# RENESAS TECHNICAL UPDATE

Product Category	MPU & MCU	Document No.	TN-16C-A218A/E	Rev.	1.00
Title	Errata to R32C/160 Group Hardware Manual		Information Category	Technical Notification	
Applicable Product	R32C/160 Group	Lot No.	Reference Document	R32C/160 Group Hardware Manual Rev. 1.02 (REJ09B0516-0102)

This document describes corrections to the R32C/160 Group Hardware Manual, Rev. 1.02.  
The corrections are indicated in red in the list below.

Figure 7.1 Clock Generation Circuitry

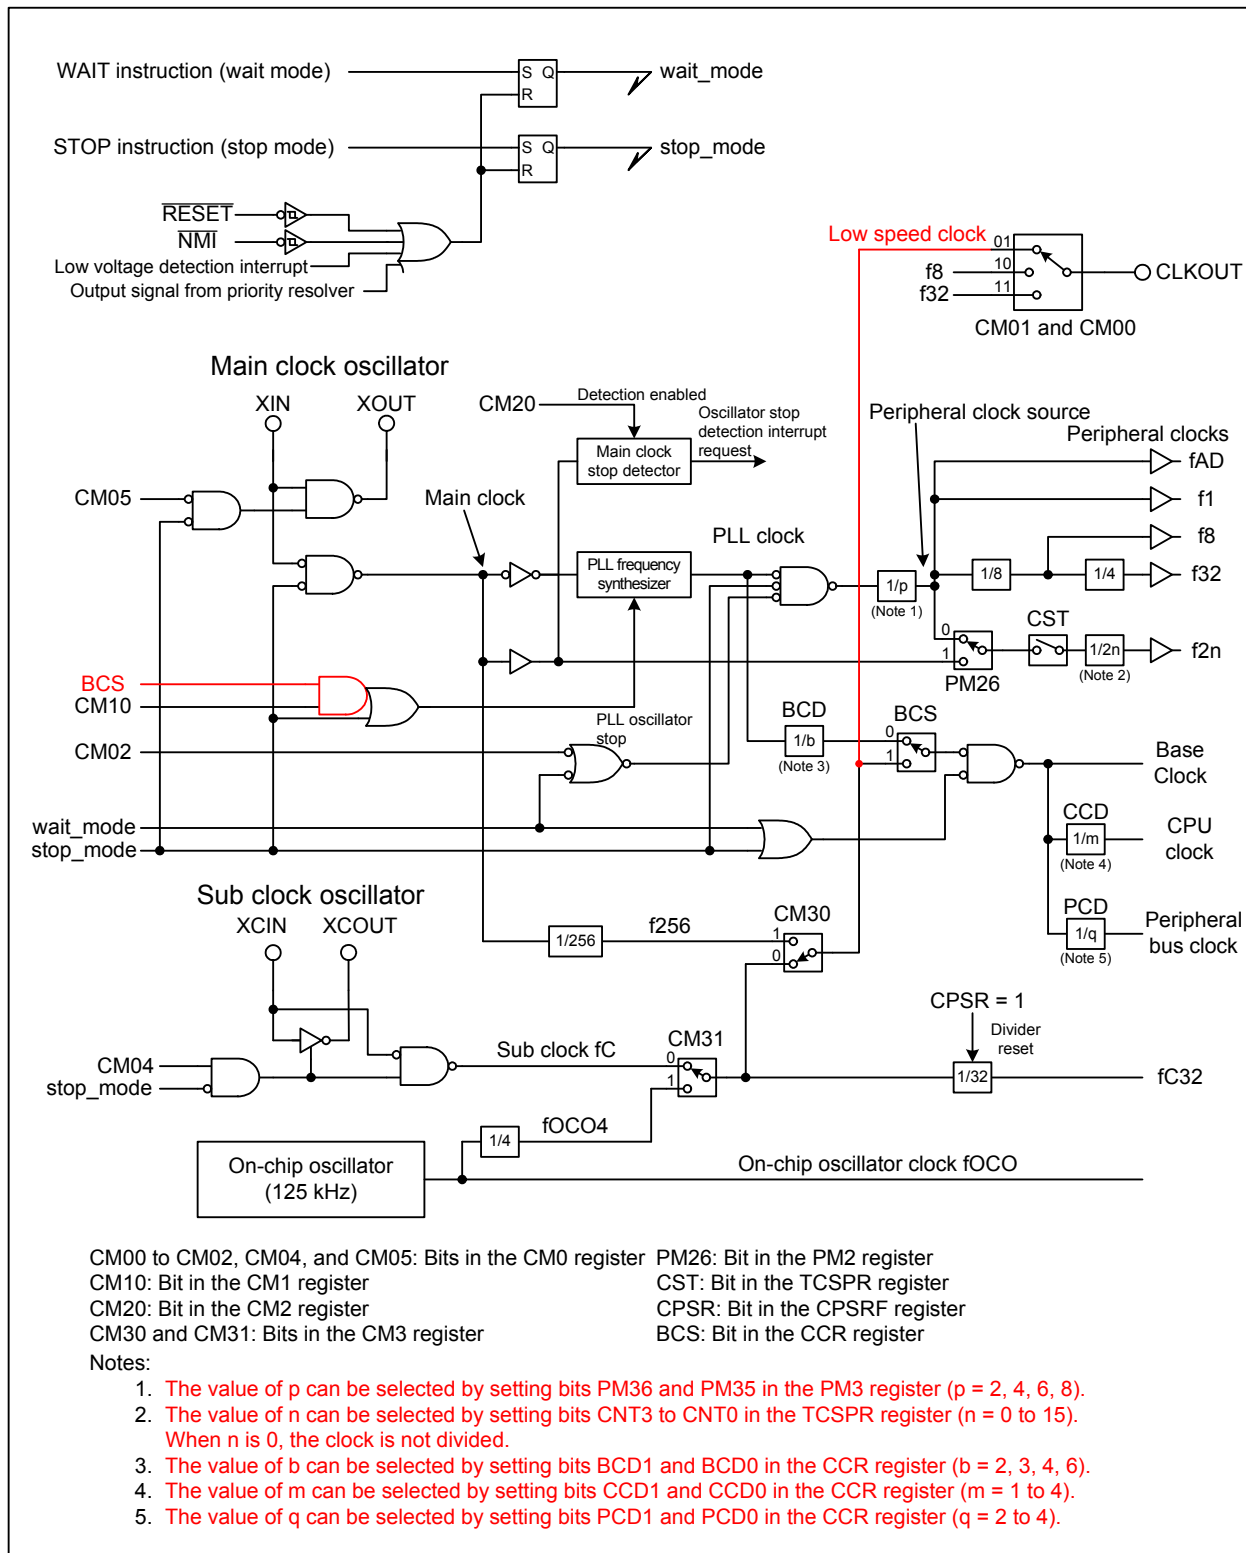
•Page 68 of 572, Figure 7.1 is corrected as follows:

**Figure 10.8 Priority Resolver**

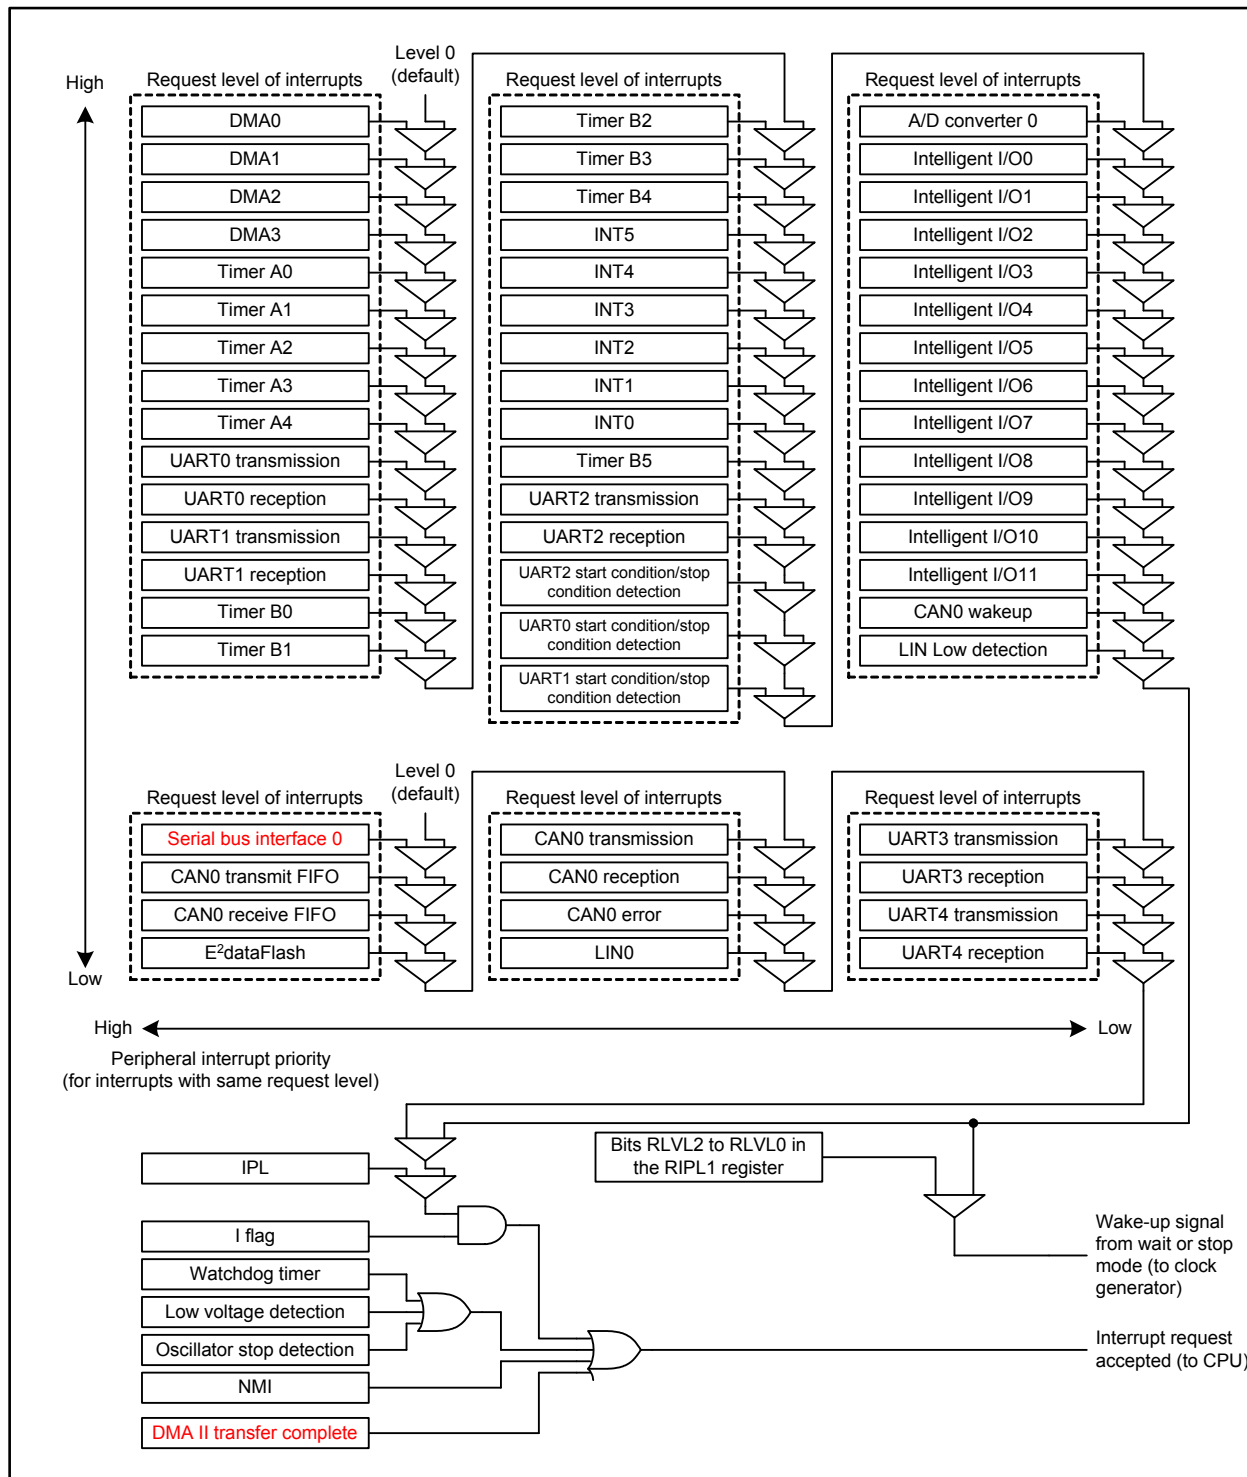
•Page 120 of 572, Figure 10.8 is corrected as follows:

(Description “Bits RLVL2 to RLVL0 in the RIPL2 register” and associated signal lines are deleted from Figure 10.8)

Figure 15.2 Timer B Configuration

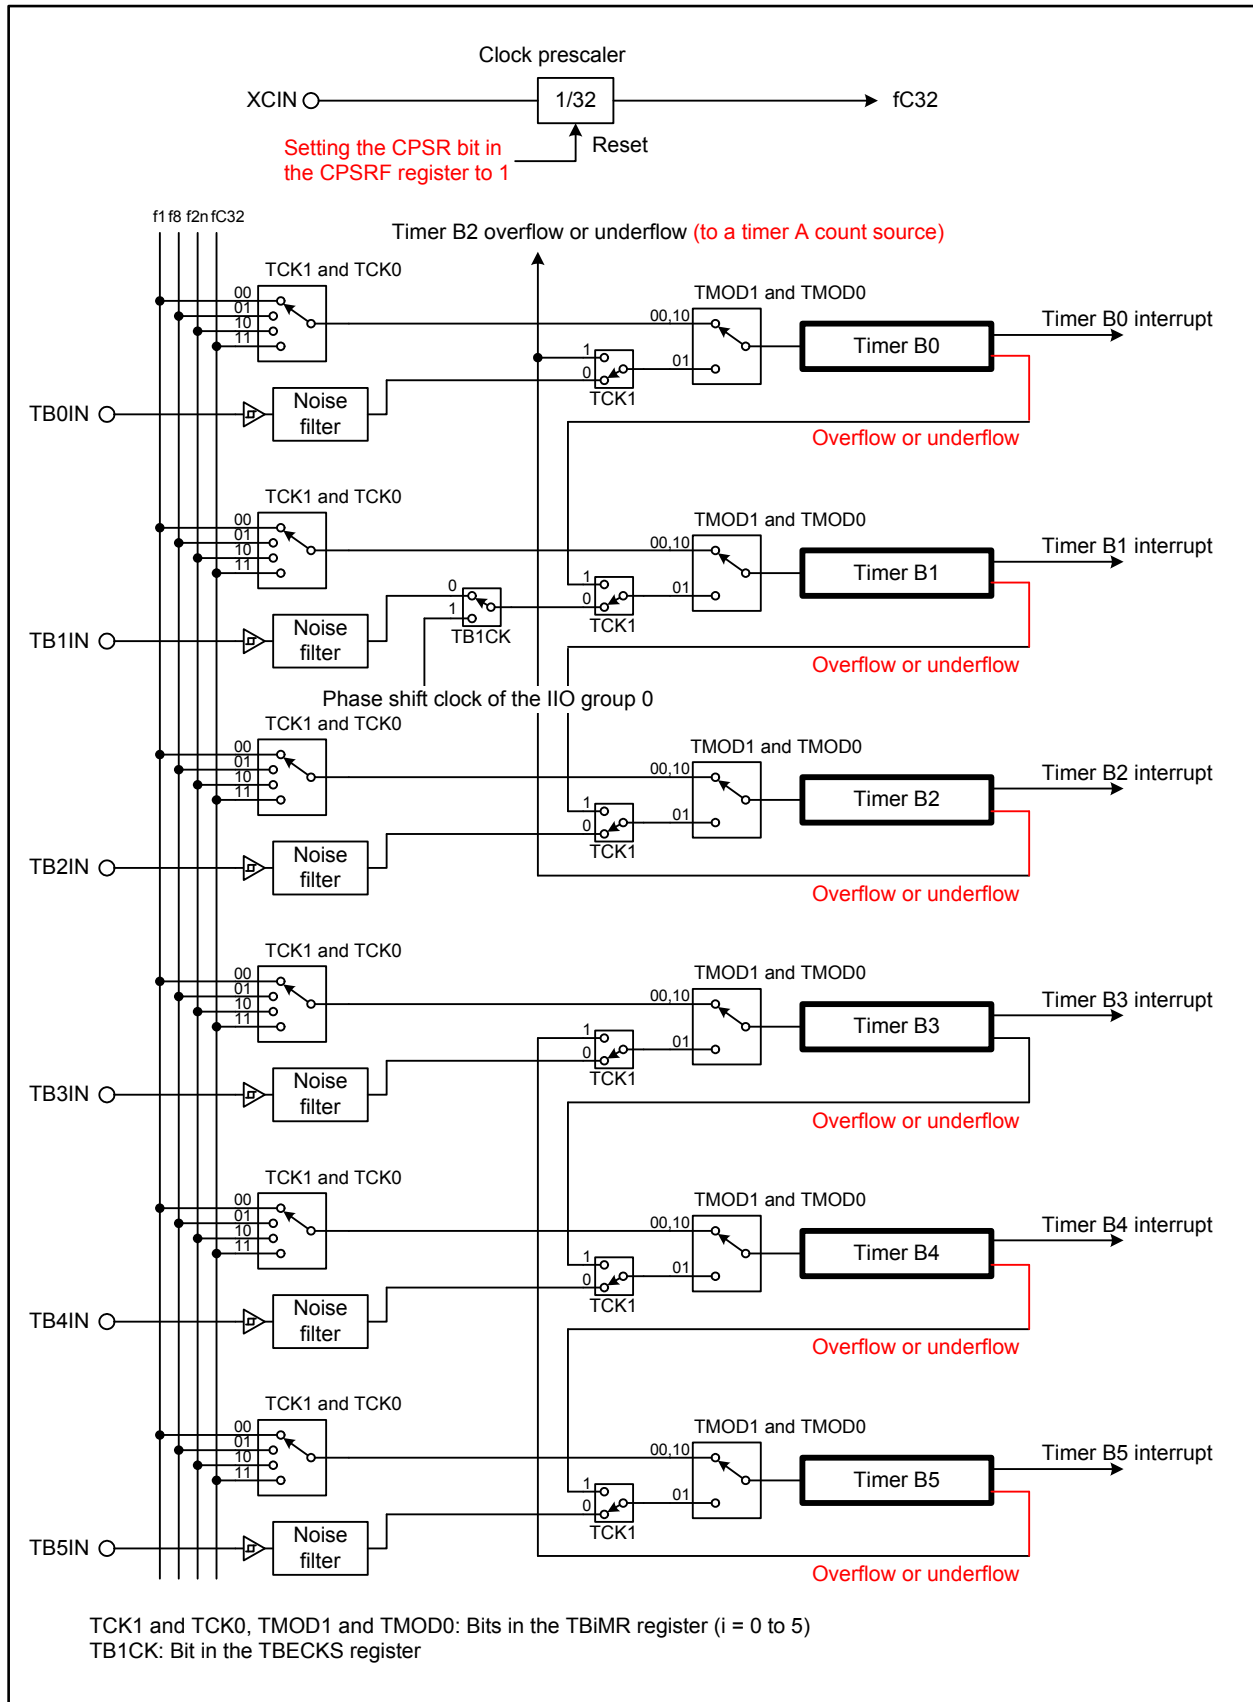
•Page 159 of 572, Figure 15.2 is corrected as follows:

**Figure 19.1 CRC Calculator Block Diagram**

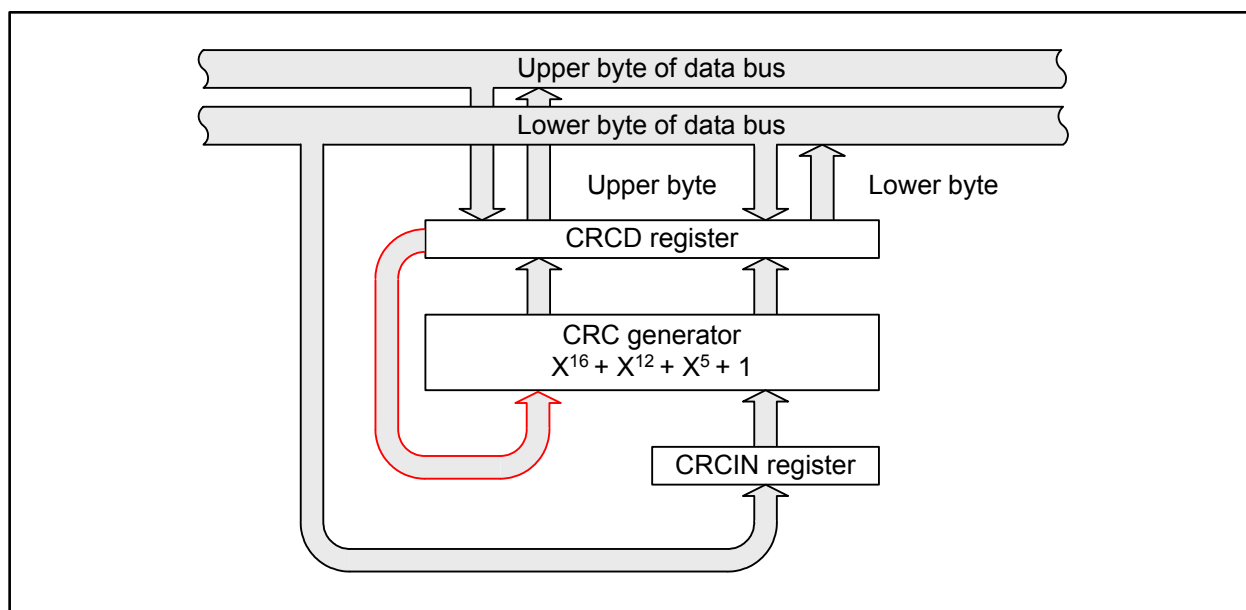
**"CRC-CCITT"**
- Page 278 of 572, Figure 19.1 is corrected as follows:

Figure 23.30 Example of Setting Before Transition to Wait Mode

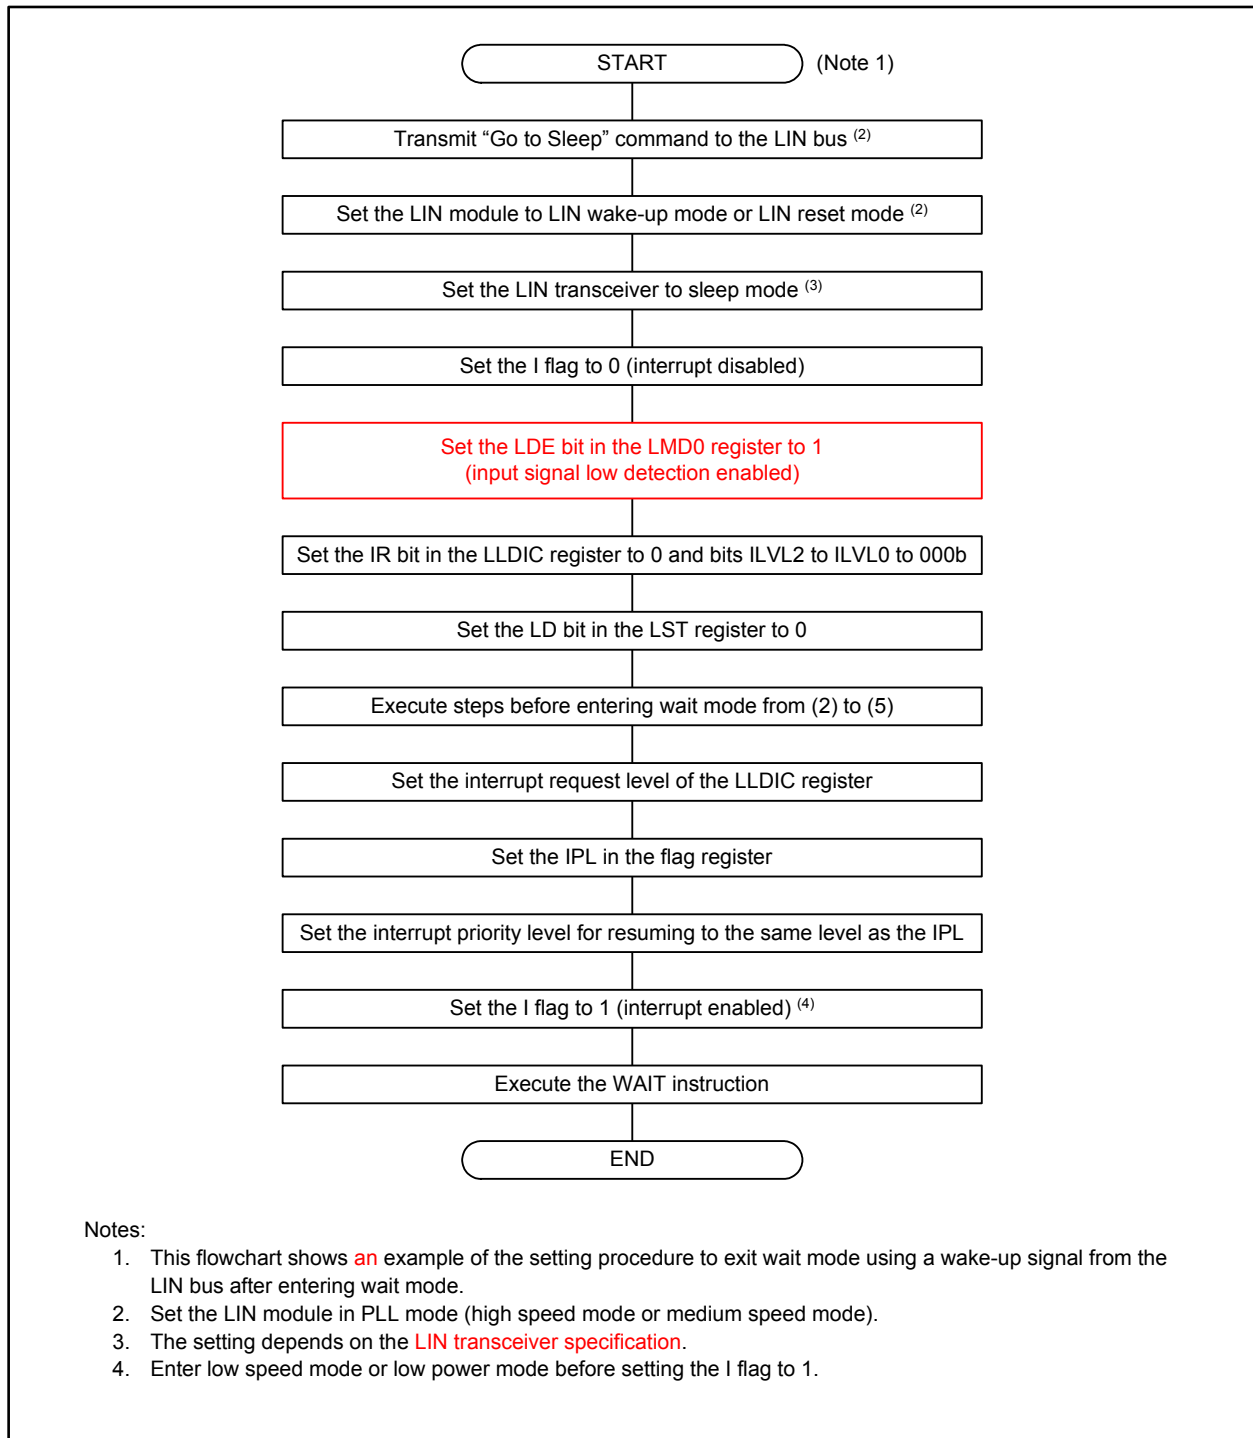
•Page 382 of 572, Figure 23.30 is corrected as follows:

Figure 23.32 LIN0 Interrupt Block Diagram

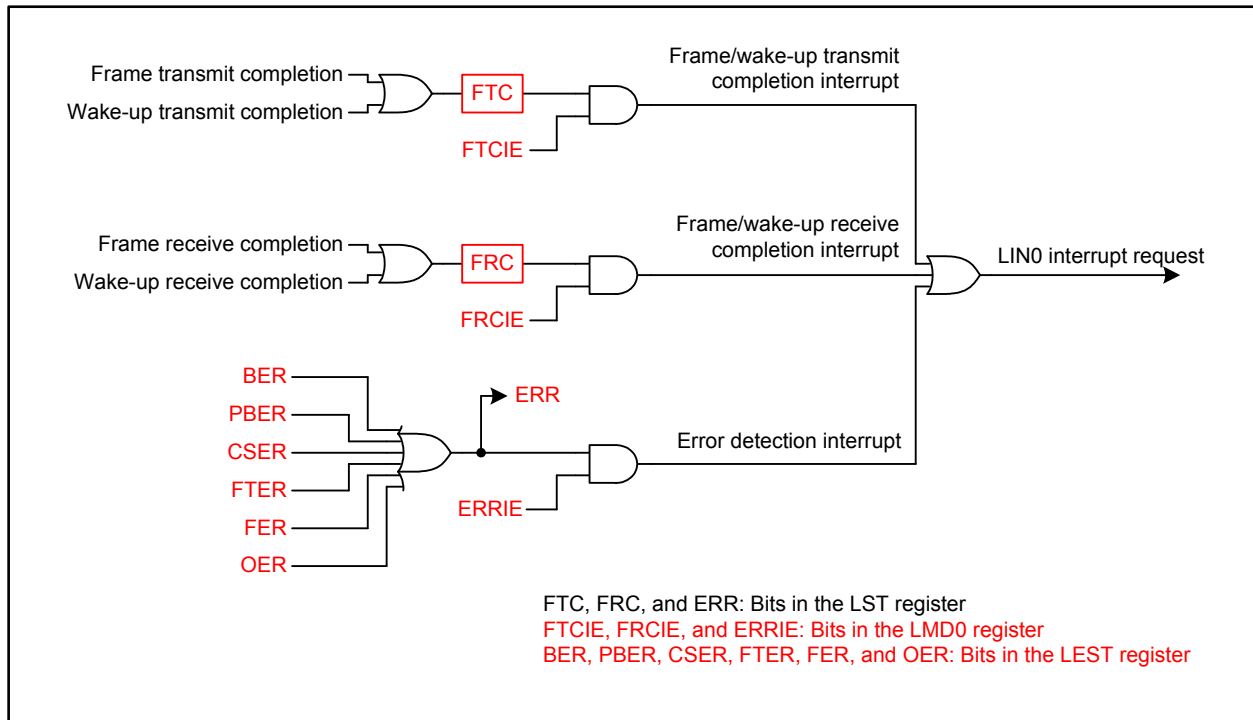
- Page 386 of 572, the following description is added to line 8 of 23.11:  
 “No new interrupt request is generated by the other sources if any of them is 1 since multiple interrupt sources are aggregated.”
- Page 386 of 572, Figure 23.32 is corrected as follows:

Figure 23.33 LIN Low Detection Interrupt Block Diagram

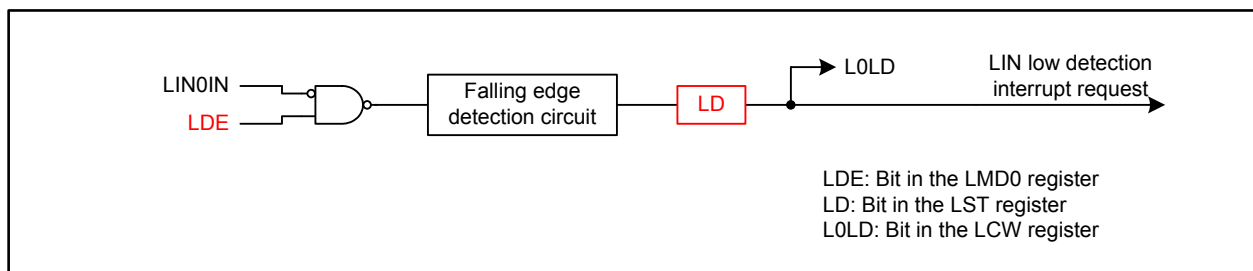
- Page 386 of 572, Figure 23.33 is corrected as follows:

Figure 25.1 Typical I/O Pin Block Diagram (i = 0 to 9; j = 0 to 7)

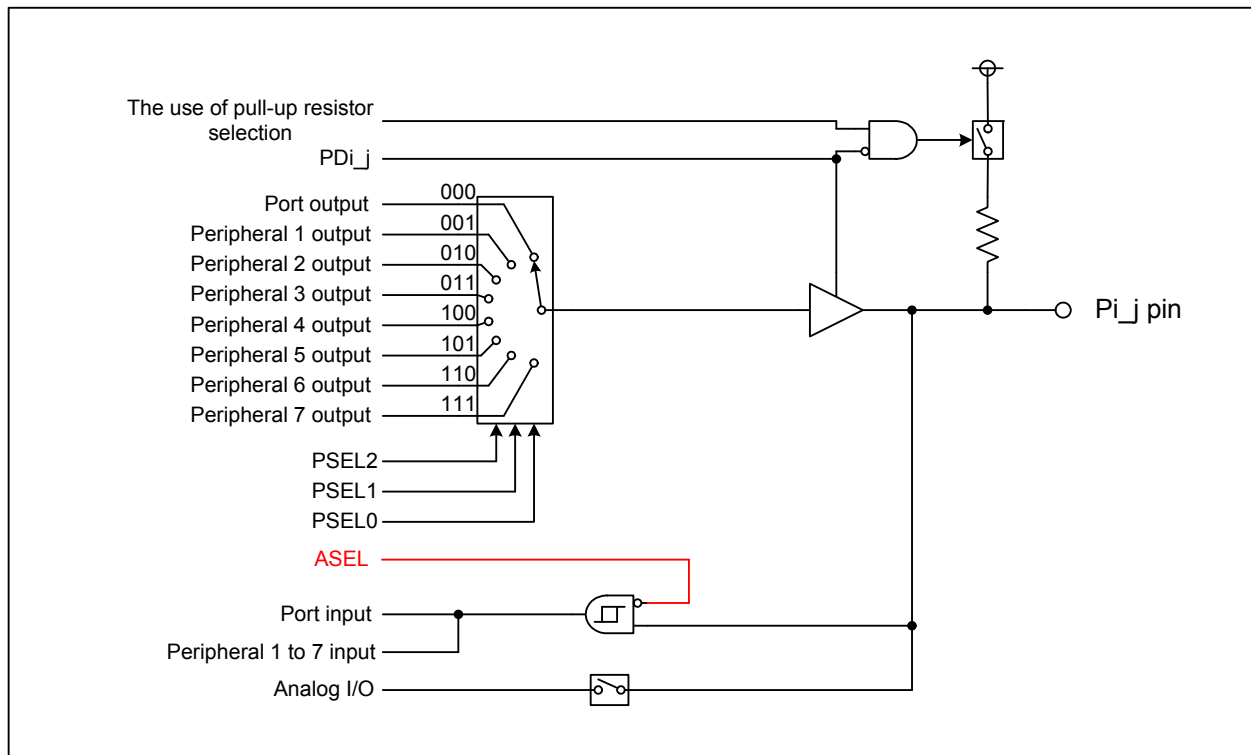
- Page 456 of 572, Figure 25.1 is corrected as follows (refer to TN-16C-A198A/E):
